- 1.1. The purpose of this report is to provide responses to questions raised in the letter dated 30 April 2021 issued by Adrian Lynham on behalf of Dorset Council (the **Request**).

- 1.2. The points addressed in this paper are in relation to the Historic Environment section of the Request (point 7), included below for convenience:

- 1.2.1. Request point 7: Further detail and assessment in respect of specific mitigation measures proposed to mitigate potential harm caused to the historic environment from the proposal, which should have regard to impacts on setting of designated heritage assets. Proposals for mitigation should include the consideration of a footpath link on Port land immediately beneath the prison.

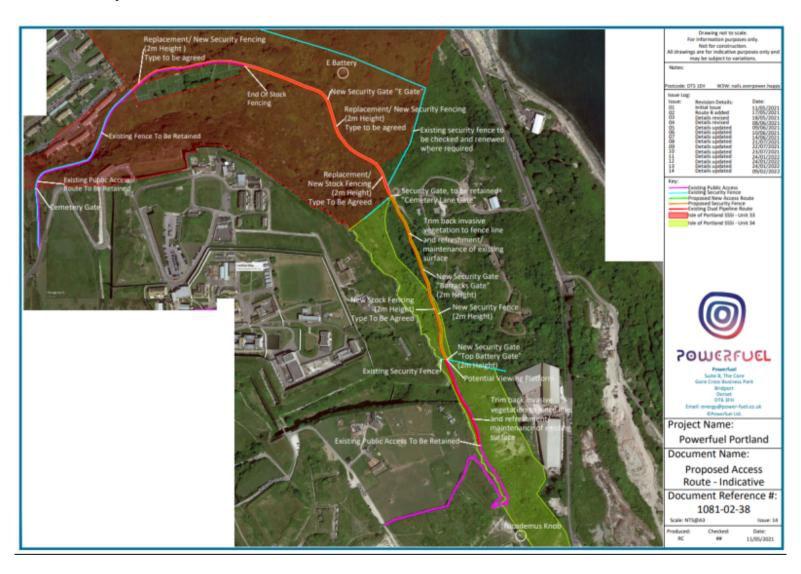
- 3.9. Post submission, the Planning Officer has raised a concern with Powerfuel that planning permission may not be granted by Dorset Council for the section of 3m security fence previously proposed and that therefore full weight could not be attributed to the footpath as part of the mitigation as there is a risk that it cannot be delivered.

- 3.10. To address this and provide the Planning Officer with comfort that the agreed footpath mitigation is deliverable and can be attributed full weight in the Officer Report, the applicant is able to clarify that Portland Port has agreed that the fence heights (and all gate heights) will have a maximum height of 2m. Plans provided in Appendix A and B of this Paper have been updated as necessary.

- 3.12. Part 2 (Minor Operations) of Schedule 2 allows "the erection, construction, maintenance, improvement or alteration of a gate, fence, wall or other means of enclosure". The provision confirms that a fence or gate that is 2m above ground level or less is permitted development and therefore does not require any further planning permission. The fence line would sit outside of the curtilage of any listed structures such that permitted development rights would still apply.

- 3.13. To clarify, this will mean that all fencing can be erected without any planning permission being required and therefore there is no identified risk that this benefit cannot be delivered. The result being that this benefit should be attributed weight in the Officer's Report as was the intention when this was agreed in August 2021.
